Approved Section 4.55 (.....2.....) Modification Application

No.....2..... Granted on ...28 January 2020

Goulburn Hospital & Health Service Redevelopment

SITE PLAN - DEMOLITION - S4.55 MODIFICATION APPLICATION

SITE PLAN

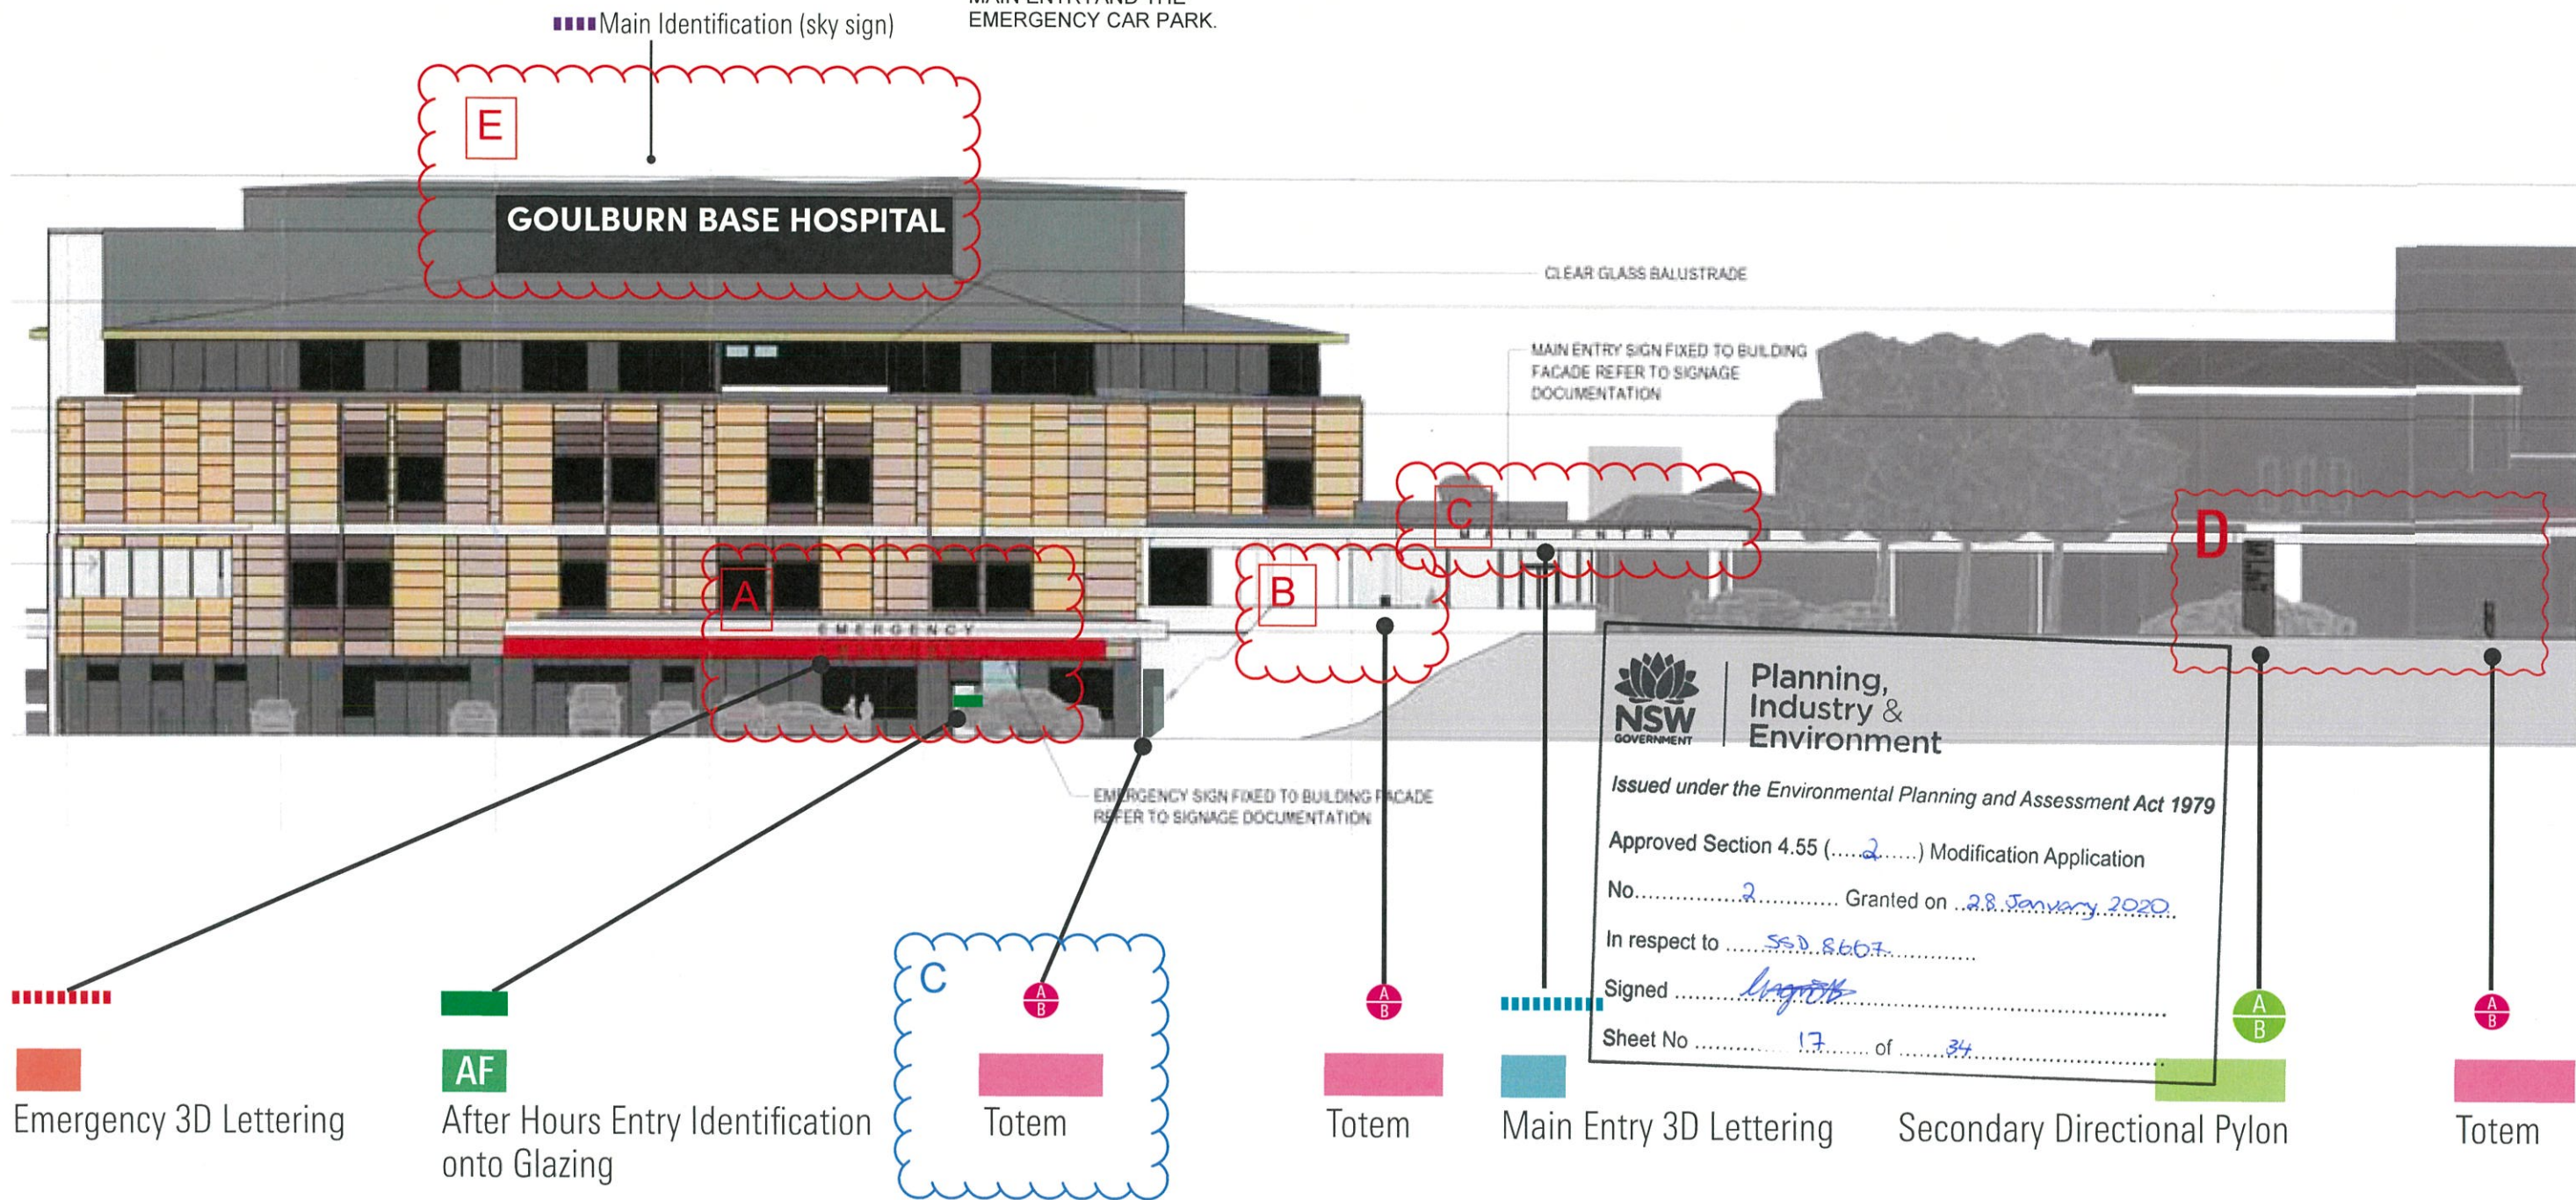
A POSITION OF OF EXTERNAL SIGNAGE HAS BEEN SLIGHTLY ADJUSTED TO MATCH THE LOCATION OF THE MAIN ENTRY POINTS. GENERAL LOCATION AND VISUAL APPROACH REMAINS THE SAME.

B AN ADDITIONAL PODESTRIAN DIRECTION PYLON HAS BEEN ADDED TO DISTINGUISH BETWEEN MAIN AND EMERGENCY ENTRY POINTS.

C BUS AND BICYCLE PARKING SYMBOLS HAVE BEEN ADDED TO DIRECT PEDESTRIANS TO THE BUS STOP ON GOLDSMITH ST AS WELL AS THE PUBLIC BICYCLE PARKS AT THE MAIN ENTRY AND THE EMERGENCY CAR PARK.

EXTERNAL BUILDING SIGNS
NORTH & WEST ELEVATION

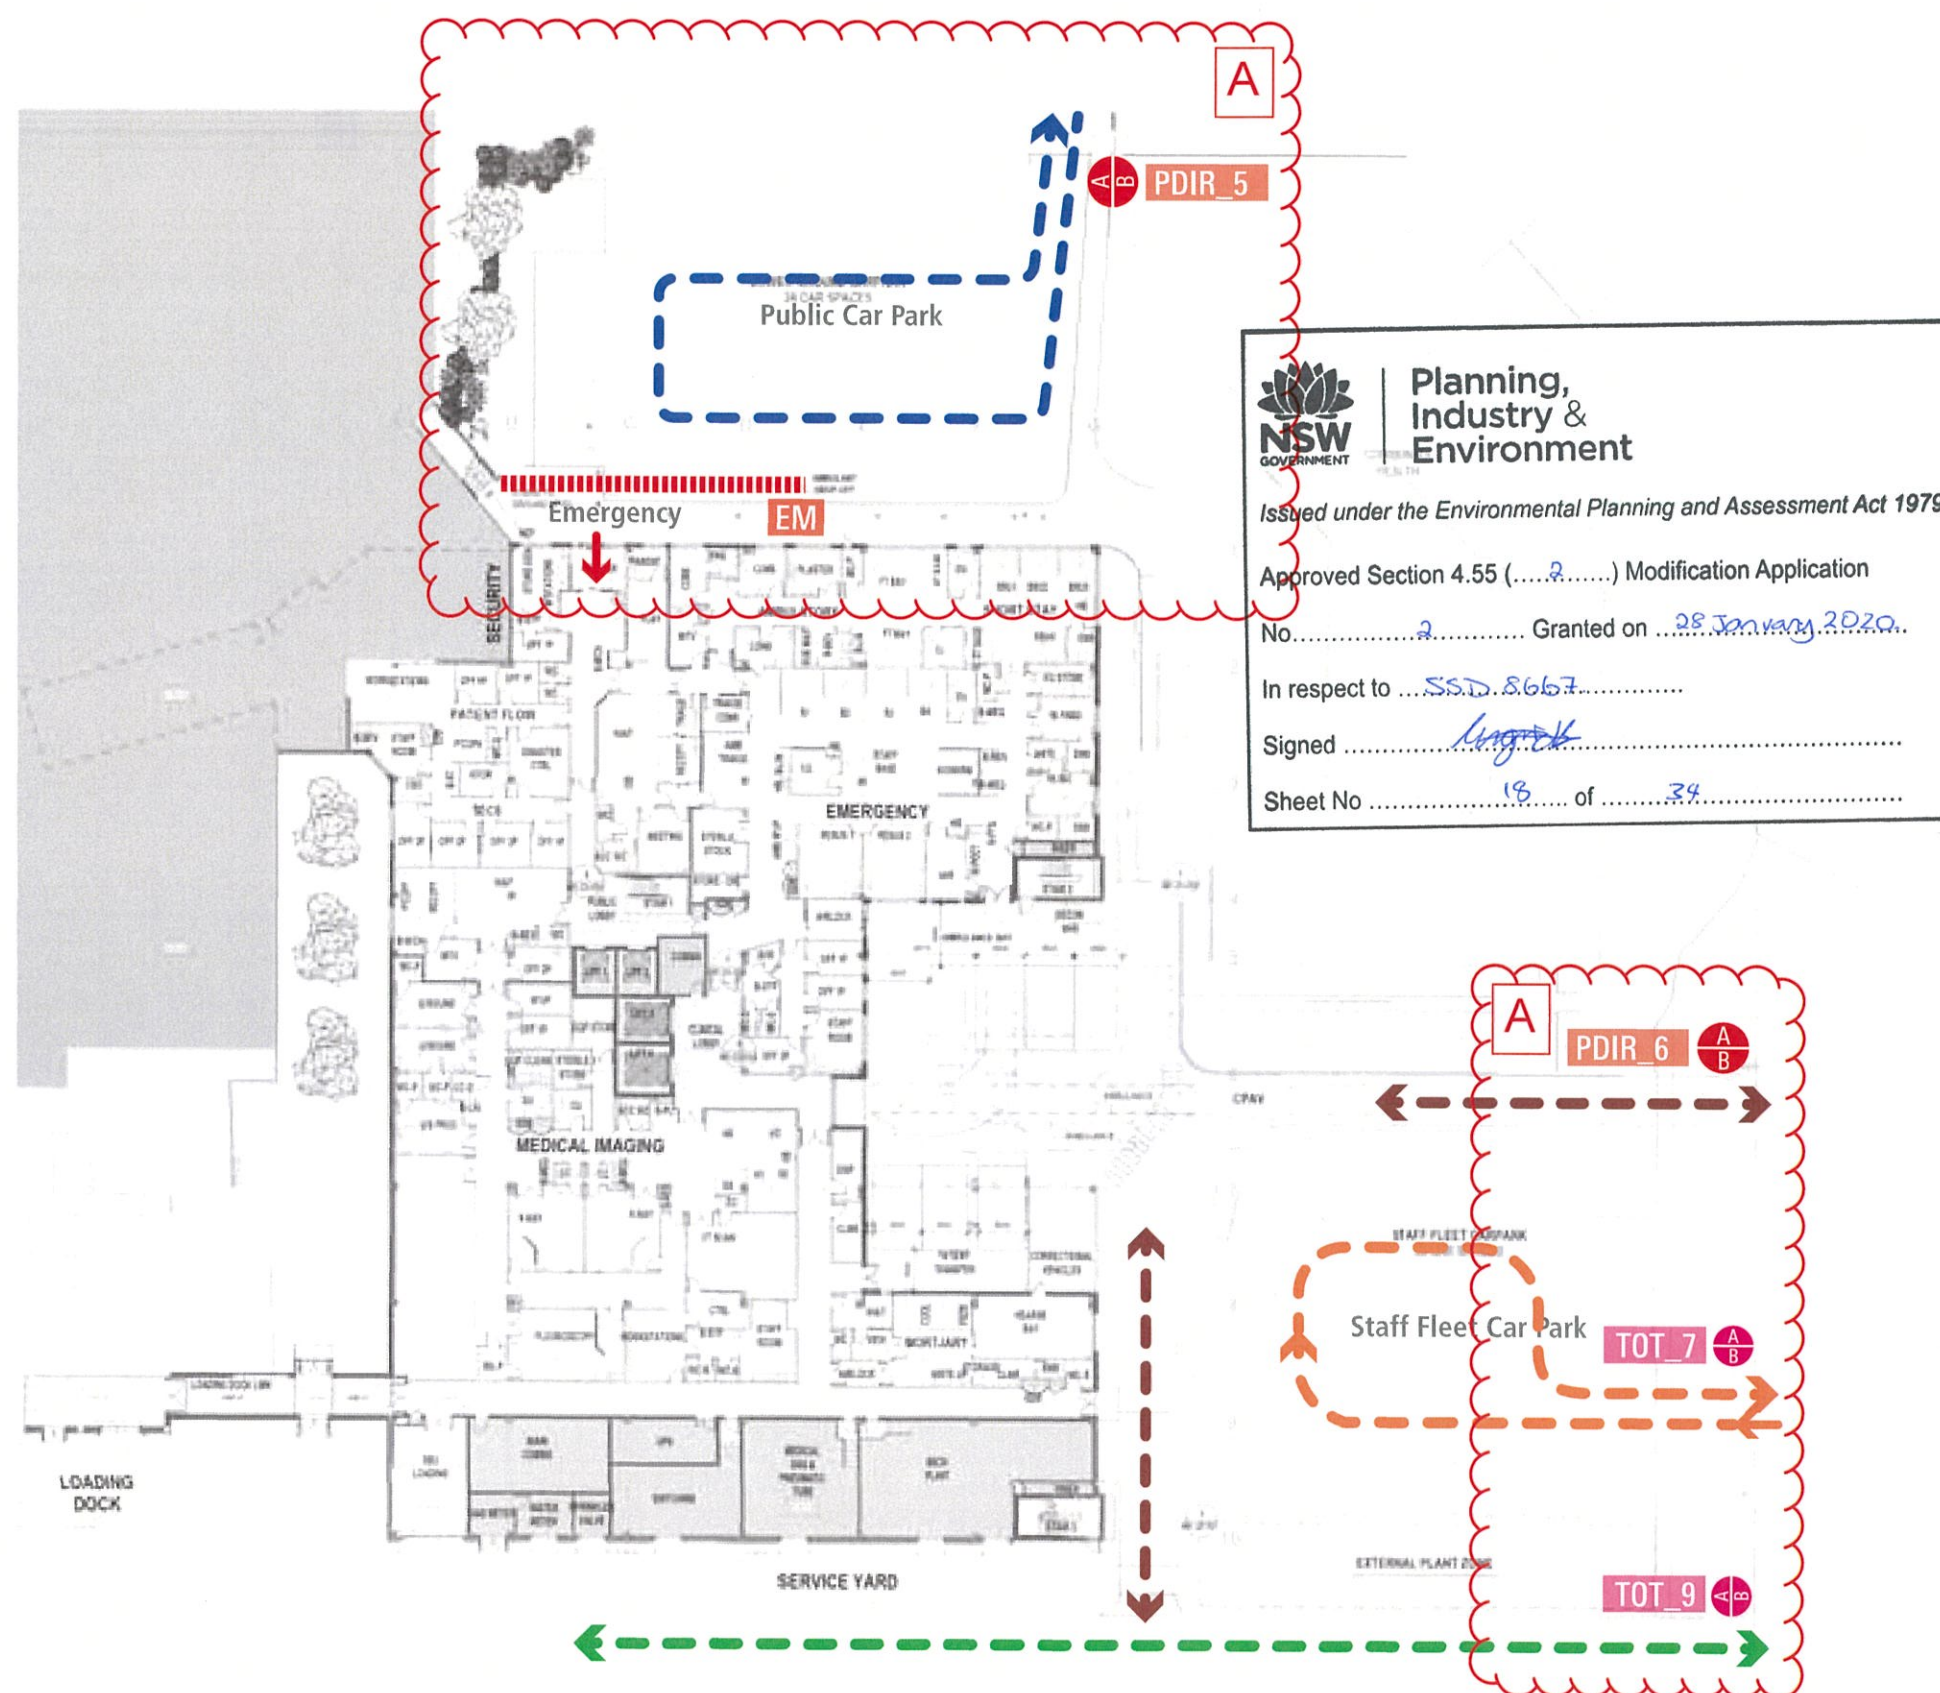
A EMERGENCY SIGN HAS BEEN INCORPORATED INTO CANOPY. LOCATION IS SIMILAR TO APPROVED SCHEME.

B AN ADDITIONAL PEDESTRIAN DIRECTION PYLON HAS BEEN ADDED TO DISTINGUISH BETWEEN MAIN AND EMERGENCY ENTRY POINTS.

C MAIN ENTRY SIGN HAS BEEN INCORPORATED INTO THE CANOPY. ADDITIONAL SPACING BETWEEN LETTERING. FONT REMAINS THE SAME.

D POSITION OF EXTERNAL SIGNAGE HAS BEEN SLIGHTLY ADJUSTED TO MATCH THE LOCATION OF THE MAIN ENTRY POINTS. GENERAL LOCATION AND VISUAL APPROACH REMAINS THE SAME.

E GENERAL POSITION OF SKY SIGN IS THE SAME AS WELL AS FONT AND SIZE HOWEVER COLOUR HAS BEEN ADJUSTED TO PROVIDE APPROPRIOT VISUAL CONTRAST.
